Ronan Airport

Standards Review
Nonstandard Conditions & Notes

RUNWAY: 16/34
ARC: B-I (SMALL)
APPROACH CATEGORY: VISUAL

Runway 16 / 34

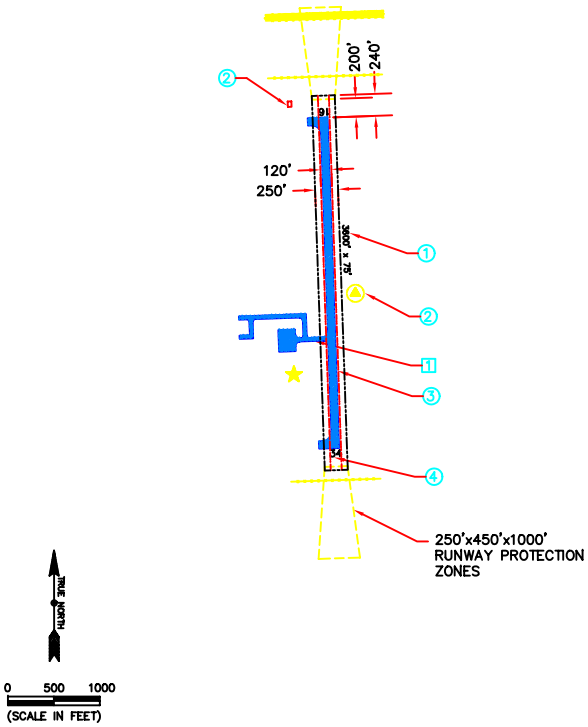
1. RUNWAY LENGTH RECOMMENDED TO MEET 100% OF SMALL AIRCRAFT NEEDS (4,780 FT).
2. WINDCONE AND BARN PENETRATE TRANSITIONAL SURFACE.
3. PAVEMENT EDGES ARE FLUSH.
4. DISKING OF SOIL IN RSA.

1. PAVEMENT EDGES ARE FLUSH.
